Addendum

Project:	M3 Junction 12 Improvements		
Subject:	Model Forecasting and Option Report - Addendum		
Author:	Akash Prakasan, Robert Sheal	Atkins No.:	5163196
Date:	03/12/2018	Icepac No.:	
		Project No.:	
Distribution:	Graham Tuck	Representing:	Eastleigh Borough Council

Revised Option - Proposed Changes

Drawing Title
GENERAL ARRANGEMENT (REVISED OPTION)

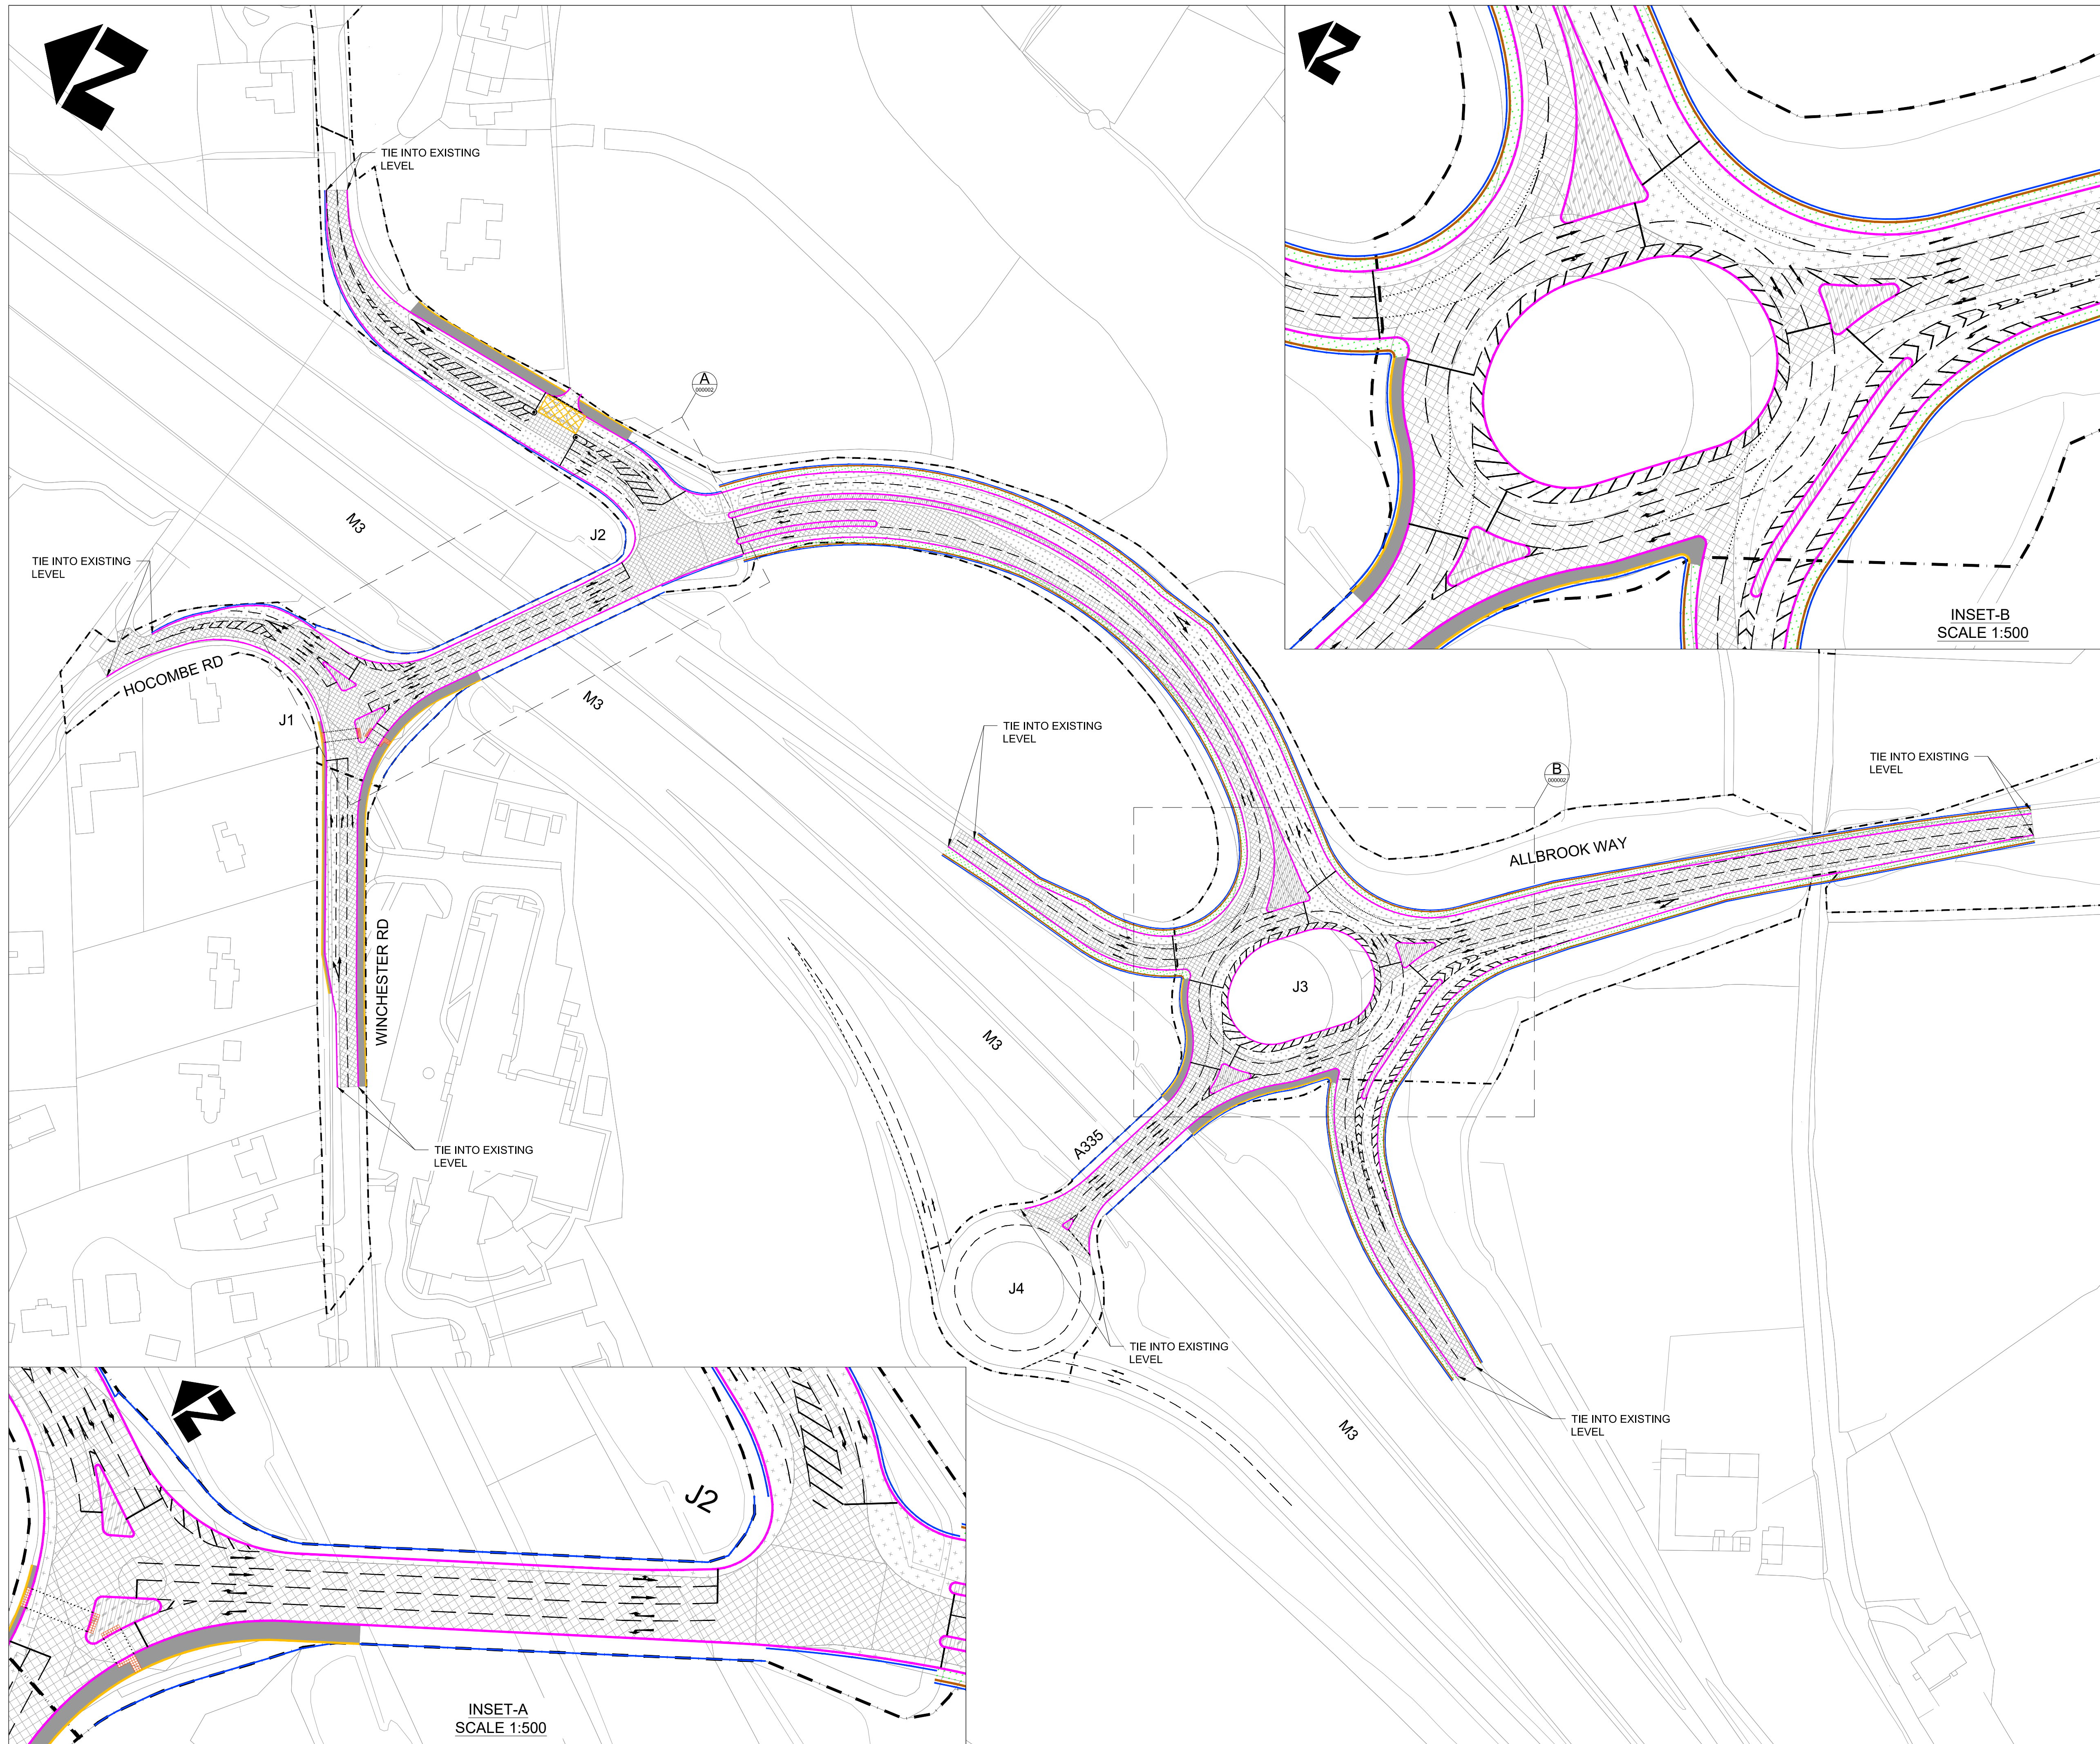
In discussions with Atkins SNC Lavalin design colleagues, the Revised Option includes a number changes as detailed below, and shown in Drawing 5163169-ATK-HML-0000-M2-CH-000002_Option_6, attached in Appendix B.

The junction has been left unchanged with four lanes retained on the motorway overbridge. Testing was undertaken with the aim of reducing the number of lanes to three by converting the two long lanes on the J1 approach to one long lane and one short lane. Design constraints (particularly the bridge structure itself) meant that the proposed right-turn flare was of insufficient length to accommodate the demand in the PM peak and that queues backed up from J1 through J2 to J3.

The number of lanes for the ahead movement from Winchester Road to the motorway overbridge has been reduced from two lanes to one lane. Testing was also undertaken to determine whether the length of the two-lane section southbound on Otterbourne Road on the approach to the signal at the hospital access could be reduced. Queueing on Otterbourne Road is sensitive to capacity for right-turners at J2 however and it was not possible to reduce the length of the two-lane section without long queues forming.

The number of lanes on the M3 Junction 12 motorway overbridge has been reduced to from four lanes to three lanes. This has meant that the western part of the J3 roundabout circulatory has been reduced from four to three lanes and the southern part from three to two lanes. The by-pass proposed from the Winchester Road to Allbrook Way arms has been removed and the flare on the Allbrook Way approach has also been removed, reducing the number of lanes on the approach from three to two.

Initial modelling with LinSig revealed Allbrook Way require a full two lanes southbound as previously proposed.

The westbound entry into the roundabout has been reduced from two to one lane with the reduction of the number of lanes on the bridge from four to three.

- A reduction in the number of lanes proposed on the M3 Junction 12 junction motorway overbridge from four to three;
- A reduction in the number of lanes proposed on the M3 Junction 12 eastern roundabout from four to three on the western part of the circulatory carriageway and from three to two on the southern part;
- Removal of the proposed free flow by-pass from Winchester Road to Allbrook Way;
- Reduction in the number of lanes proposed at the Allbrook Way entry on to the eastern roundabout from three to two, and;
- Reduction in the number of lanes proposed westbound towards the motorway overbridge from two to one on the Winchester Road approach at the Otterbourne Road/Winchester Road junction.
